Item 7.**Development Application: 75 Kepos Street, Redfern - D/2022/879****File No.:** D/2022/879**Summary****Date of Submission:** 25 August 2022, amendments submitted 21 September 2022**Applicant:** Mr Andrew James Morony**Architect:** Lintel Studio**Owner:** Mr Andrew James Morony
Mrs Michelle Elizabeth Morony**Planning Consultant:** GSA Planning**Heritage Consultant:** Weir Phillips Heritage and Planning**Cost of Works:** \$1,386,990.00**Zoning:** The site is located within the R1 General Residential zone. The proposal, defined as an attached dwelling, is permissible with consent.**Proposal Summary:** The subject application seeks consent for alterations and additions to an existing terrace, including reconstruction of the main gable roof, and construction of a new front dormer window, a two storey rear addition, associated internal alterations, and a new rear boundary fence and bicycle storage.

The proposed development exceeds the 'height of buildings' and 'floor space ratio' development standards. Written requests to vary the development standards in accordance with Clause 4.6 of Sydney LEP 2012 are submitted.

The application is referred to the Local Planning Panel for dete

Figure 7: Approved long section of D/2015/128

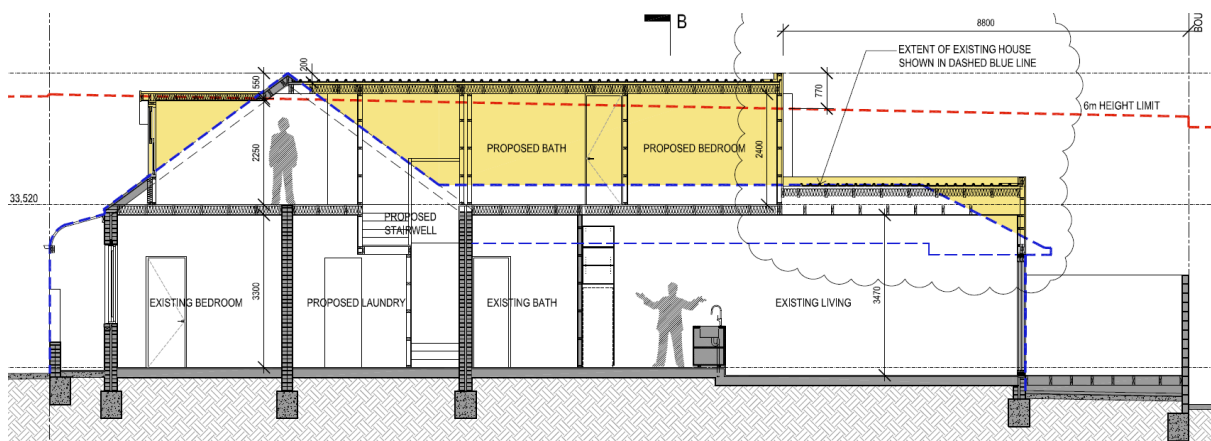
7. The following application for the subject site is relevant to the current proposal:
 - **D/2015/128** – Development consent was granted on 24 June 2015 for alterations and additions to existing dwelling house including a first floor rear addition and a front dormer window. A condition was imposed to delete a substantial portion of the first floor addition, reducing the FSR from 1.14:1 to 0.996:1, which represents a 24.5% variation to the 'floor space ratio' development standard. The consent also approved a maximum height of 6.875m, which represents a 14.58% variation to the 'height of buildings' development standard.

Figure 18: Height exceedance shown on a long section

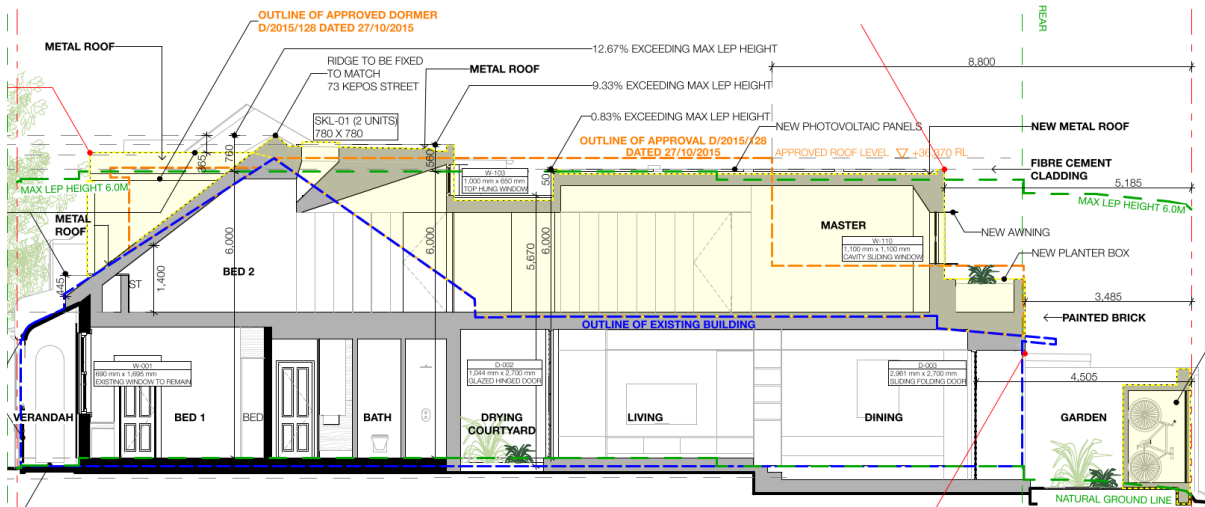
18. The site is subject to a maximum 'height of buildings' development standard of 6m. The proposed development has a maximum height of 6.76m to allow the reinstatement of the roof ridge, and to accommodate a new front dormer window and a rear addition that is consistent with the scale of other two storey rear additions along Kepos Lane.

19. The variation is a maximum of 0.76m (12.6 per cent), observed at the reinstated main ridge. All areas above the maximum 6m height plane, denoted by a green dotted line, are identified in the section in Figure 18 below.
